Workman® 3000 and 4000 Vehicles

Subject: Availability of a High Air Intake Kit.

Ref: 03-01 Copyright[®], 1995. The Toro Company

HIGH AIR INTAKE KIT (93-8937)

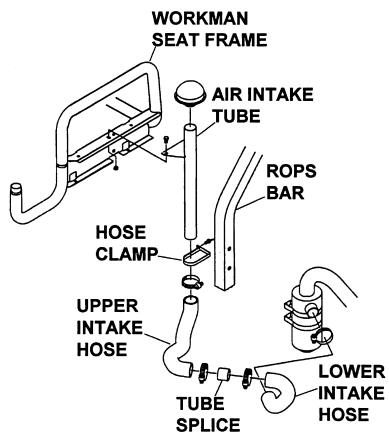
When operating in extremely dusty and dirty conditions or if material overflows when loading the cargo bed, debris can buildup in the radiator air intake area and become pulled into the air cleaner canister. This debris must be removed regularly to prevent plugging of the air filter element. As an enhancement, High Air Intake Kit (93-8937) is now available for all Workman Liquid Cooled Vehicles. The kit positions the air intake directly behind the passenger seat frame. This location allows the engine to draw air from a cleaner environment, reducing the possibility of debris accumulating in the air filter canister.
